PROJECT	THE OLD TOWNE HOTEL
PREPARED FOR	OLD TOWN SQUARE, LLC
LOCATION	160 ATLANTIC STREET STAMFORD, CONNECTICUT

April 15, 2022

Re: 160 Atlantic Street, Stamford CT
The Old Towne Hotel
Zoning Board Application No. 221-24

In response to your comments summarized in and Interoffice Memorandum to Vineeta Mathur, Associate Planner – Zoning Board, we have modified our set of development plans. We have enclosed one copy each of the following materials for your further review:

ZONING LOCATION SURVEY
 OF PROPERTY AT
 160 ATLANTIC STREET
 IN
 STAMFORD, CONNECTICUT
 PREPARED FOR
 OLD TOWN SQUARE, LLC

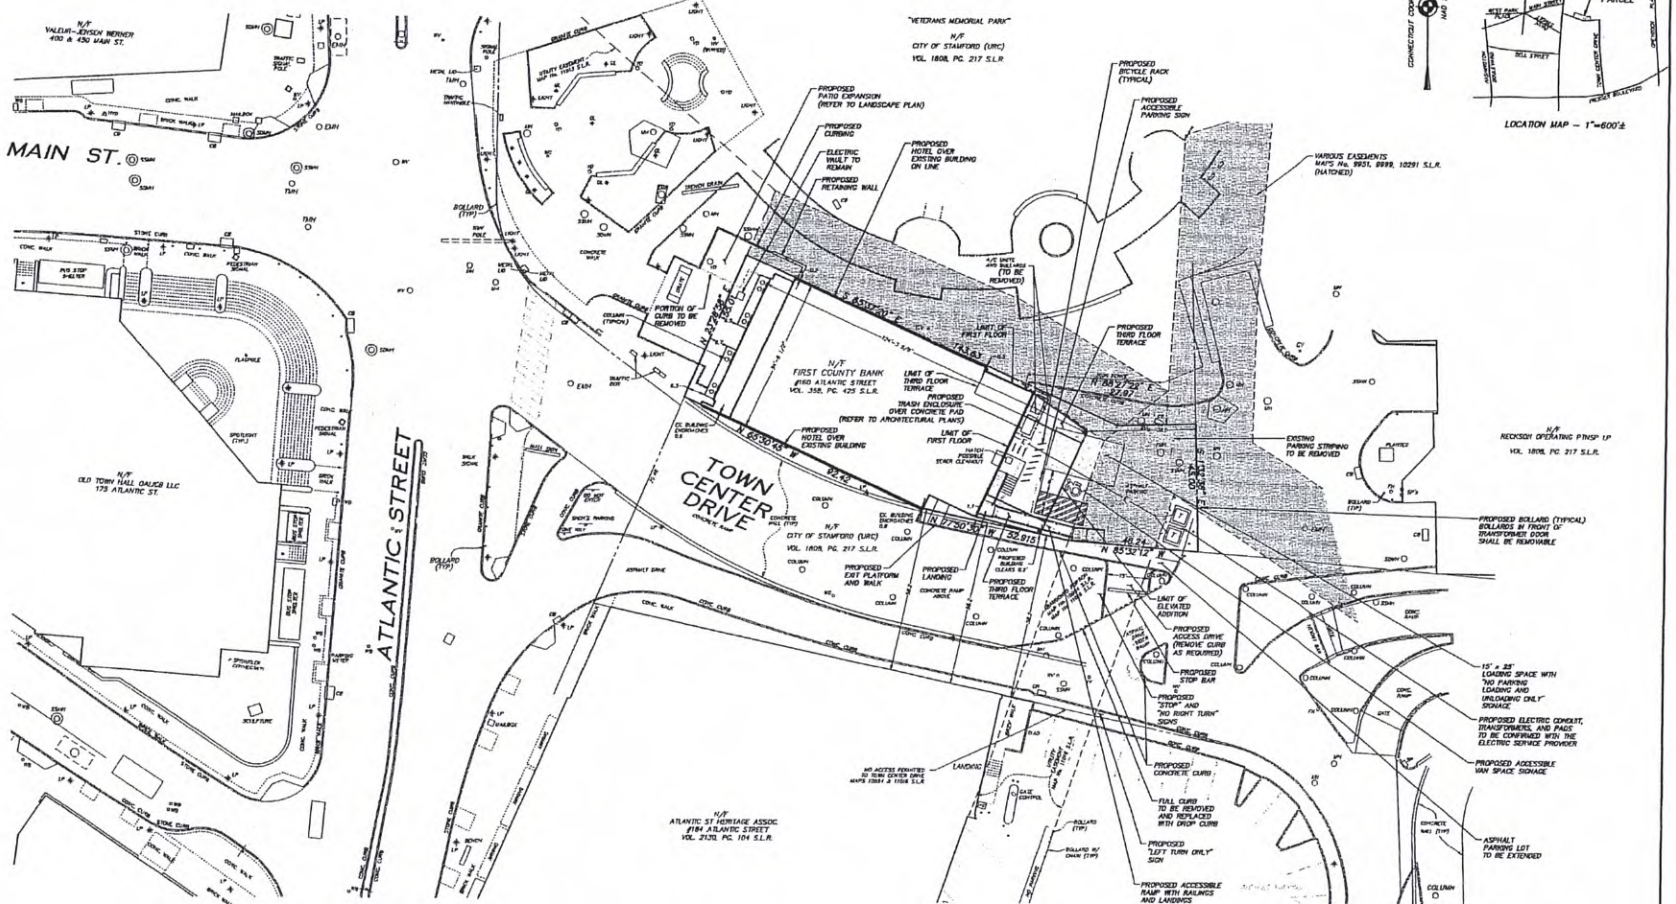
- 2) After much discussion with the land-use attorney for the project, John Leydon, the architect, and the applicant, it was decided to redesign the building expansion such that all parts of the proposed building clear all recorded easements. It is recognized that portions of the proposed patio fall within Veterans Park and the Attorney Leydon is negotiating the use with the applicable Stamford agencies. The proposed uses are also made a part of the Zoning Board site plan application. To clarify a further point relative to parking, the application reduces the existing number of spaces from 12 to one accessible van space, and one loading space that will both be located within the subject property. The application also recognizes that access to the existing and proposed spaces is over Town Center Drive roadway, and property owned by others. Attorney Leydon is addressing the continued use of the access route with each respective land owner. General Survey Note 4 on the Zoning Location Survey also recognizes the need to secure all required use agreements.

PROJECT	HOTEL DEVELOPMENT
PREPARED FOR	OLD TOWN SQUARE, LLC
LOCATION	160 ATLANTIC STREET STAMFORD, CONNECTICUT
SHEET	1 of 5 EXISTING CONDITIONS

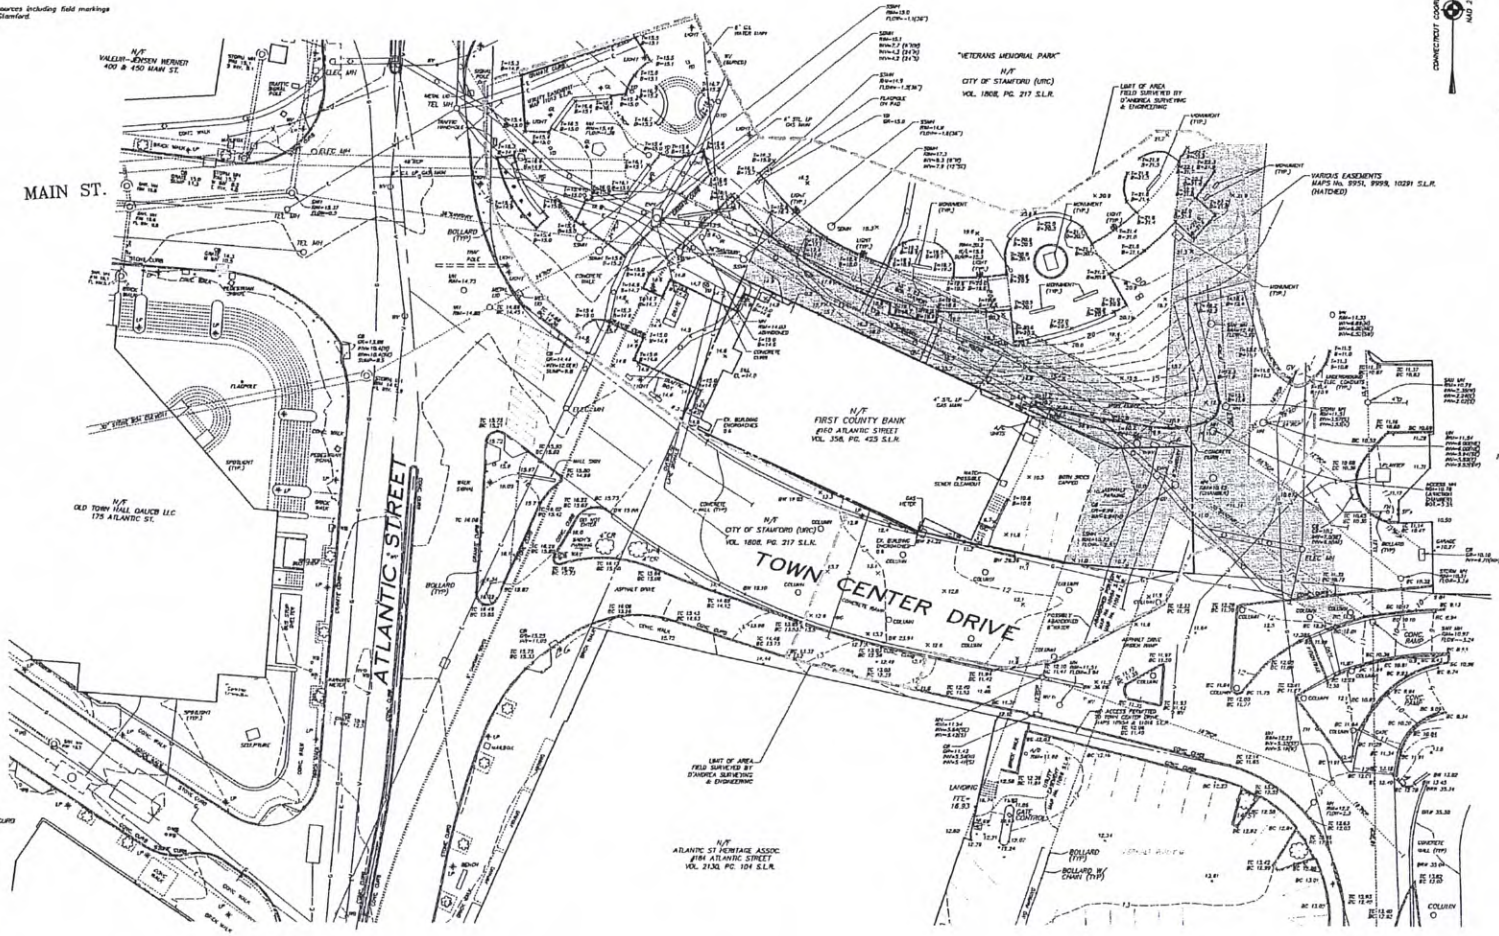
- 1) The plan set includes an “Existing Conditions” land survey map prepared in accordance with the Connecticut State Regulations 20-300b-1 through 20-300b-20, signed and sealed by a Connecticut Registered Land Surveyor.

PROJECT	FOR	THE OLD TOWN HOTEL
PREPARED FOR	OLD TOWN SQUARE, LLC	
LOCATION	160 ATLANTIC STREET STAMFORD, CONNECTICUT	
2 OF 5	DEVELOPMENT PLAN

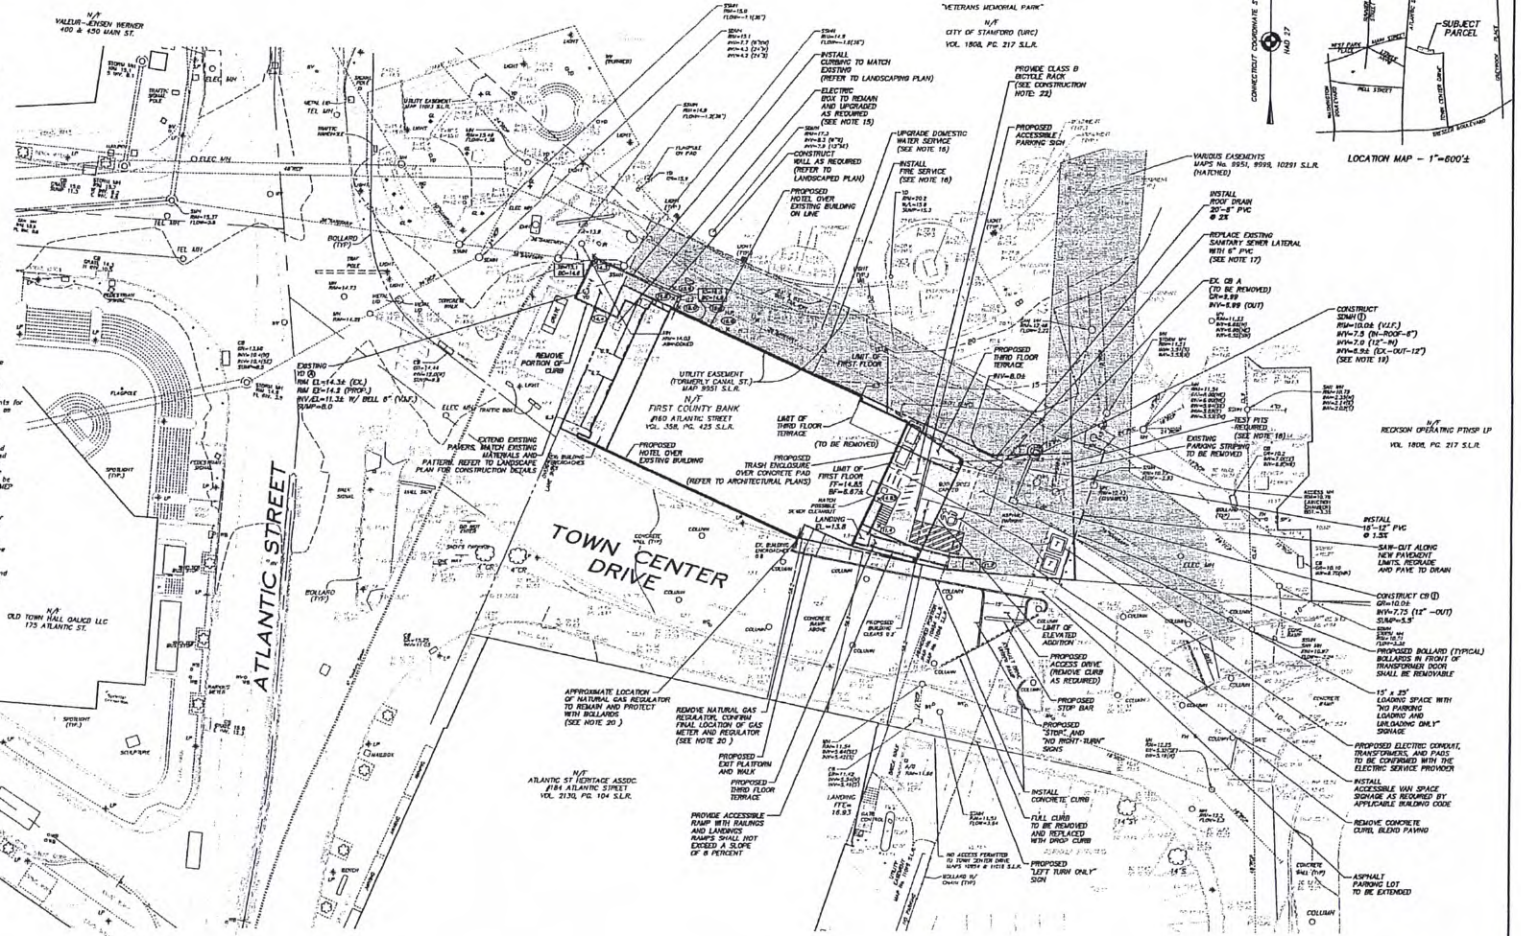
- 3) The proposed building has been redesigned to avoid encroachment into the mapped and dedeed easements.
- 4) Although it is mentioned as a yard drain located on the easterly side of the existing building in your memorandum, we believe you mean the westerly side as there is no yard drain on the easterly side of

- 10) On the previous plans, all required services had been depicted. After further discussion with the architect, and anticipating what would most likely be required by Eversource to service the proposed use, we have added two proposed transformers. The location is subject to change as once the electrical engineer furthers the design requirements with the Eversource.

PROJECT	THE OLD TOWNE HOTEL
PREPARED FOR	OLD TOWN SQUARE, LLC
LOCATION	160 ATLANTIC STREET STAMFORD, CONNECTICUT
DATE	4-14-22
PROJECT NO.	2022-001
SCALE	AS SHOWN
3 OF 5	SEDIMENTATION & EROSION CONTROL PLAN

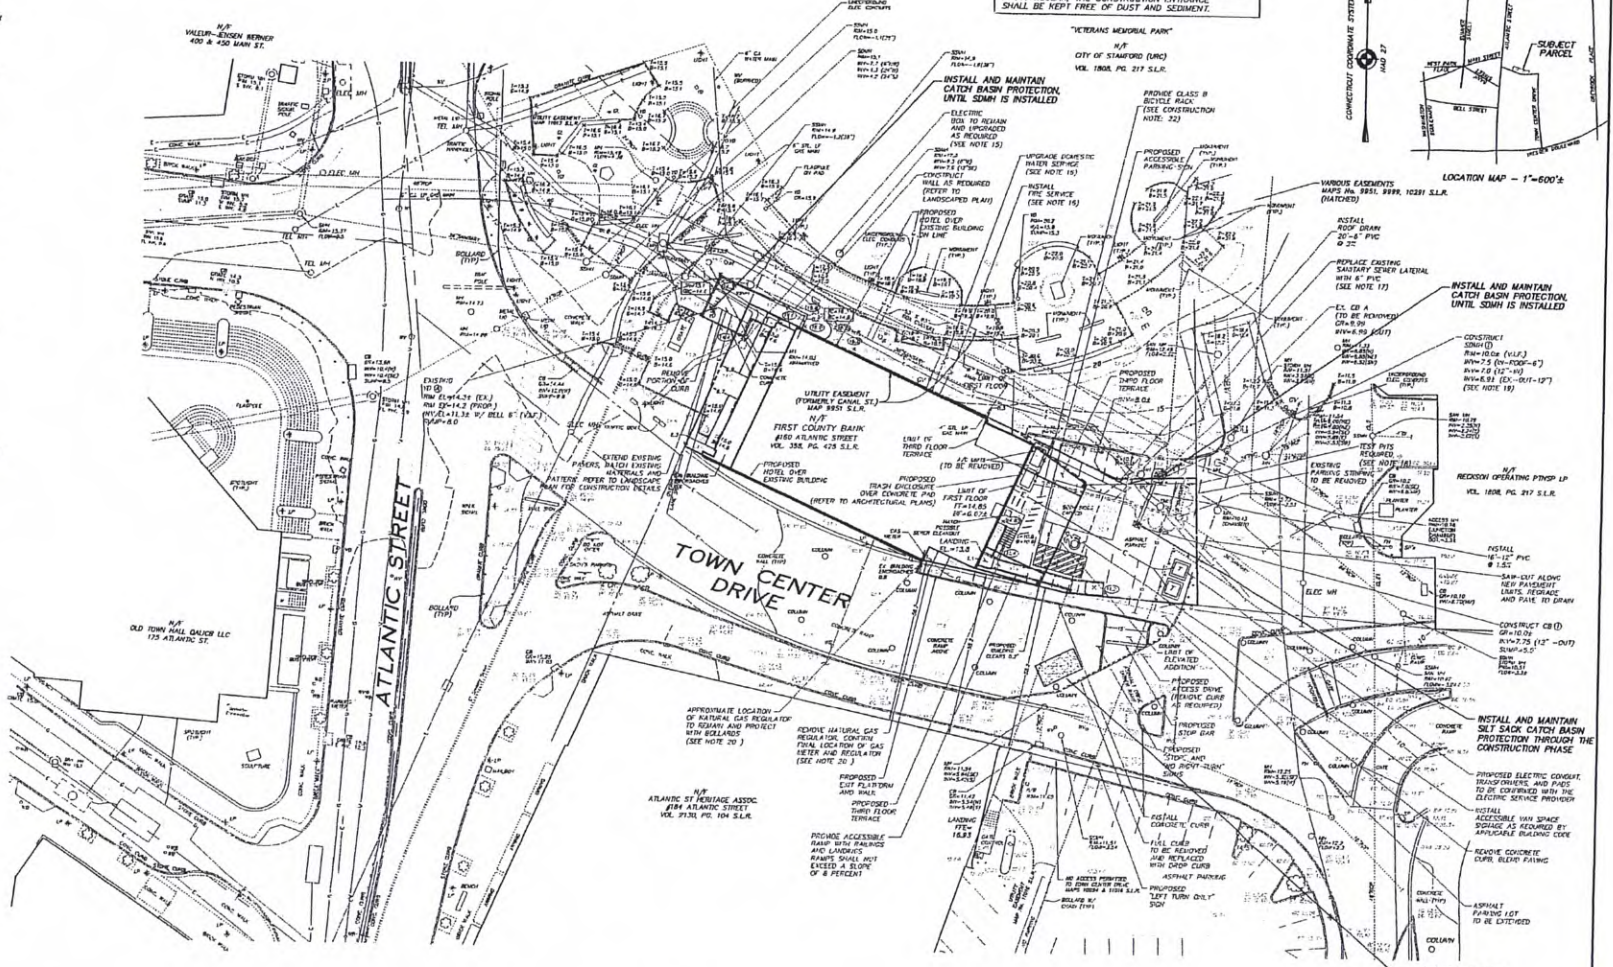
- 5) Assuming this is actually the same reference to the yard drain west of the existing building, temporary S&E measures have been added to Sheet 3 of 5 to protect the basin during construction.

PROJECT	THE OLD TOWNE HOTEL
PREPARED FOR	OLD TOWN SQUARE, LLC
LOCATION	160 ATLANTIC STREET STAMFORD, CONNECTICUT
5 OF 5	CONSTRUCTION LOGISTICS PLAN

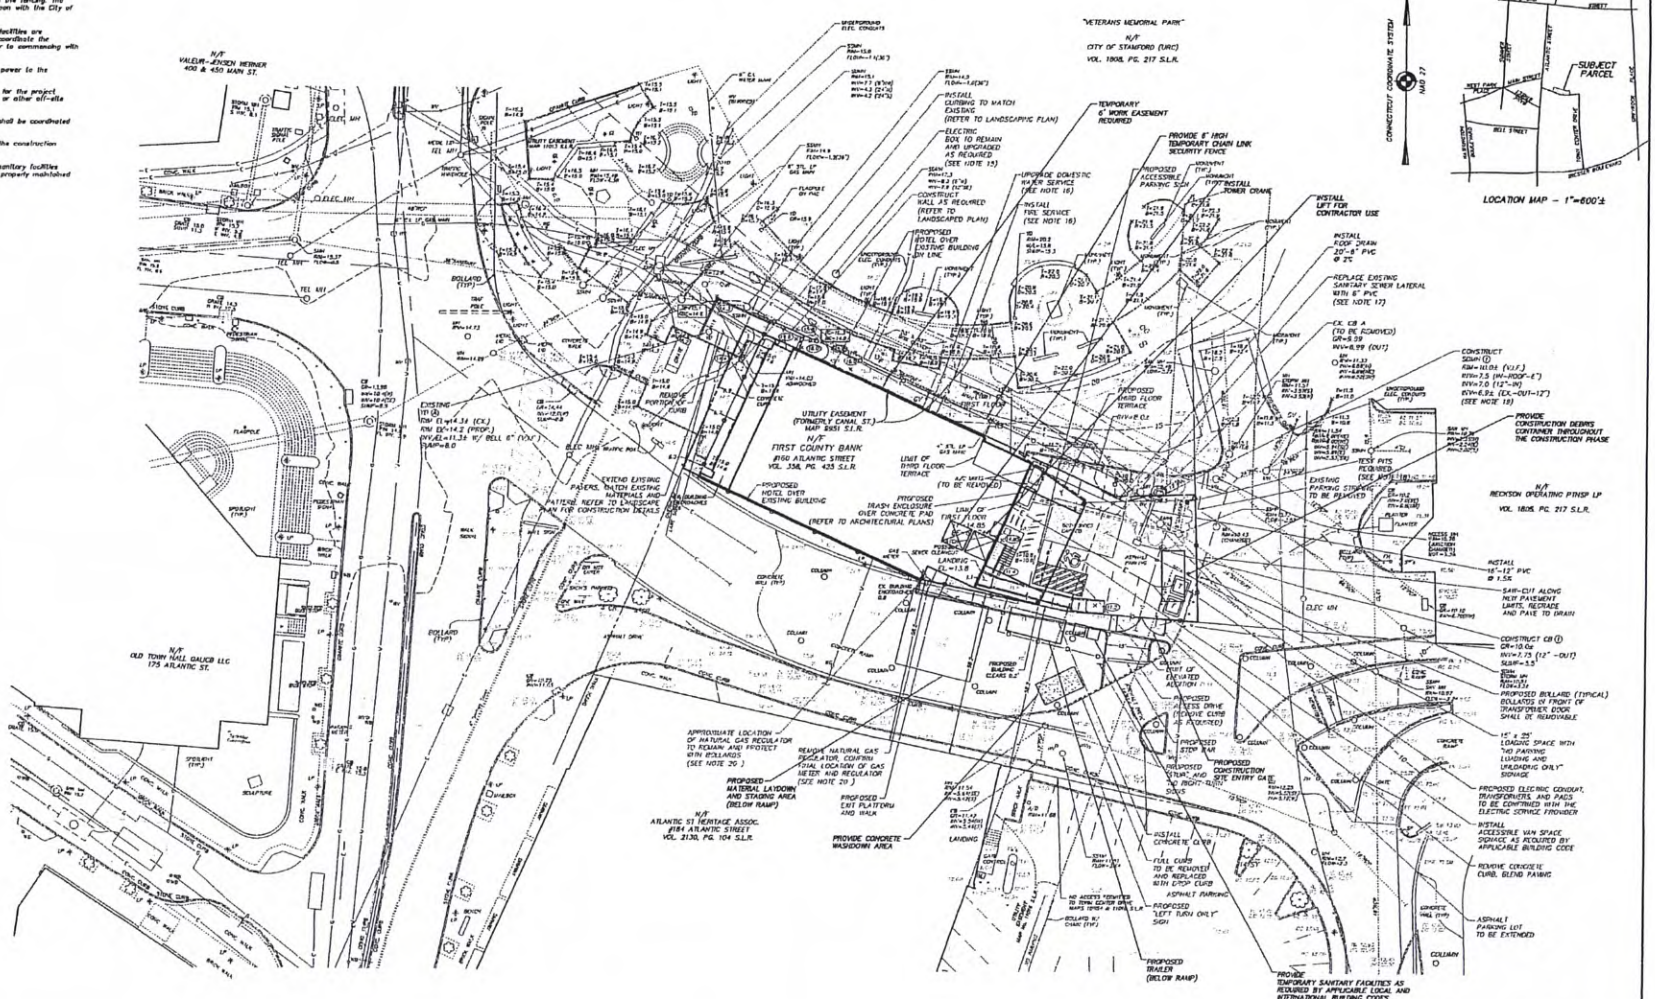
- 7) Your comment is recognized, but the Construction Logistics Plan provided notes requiring that temporary work easements be secured prior to construction.
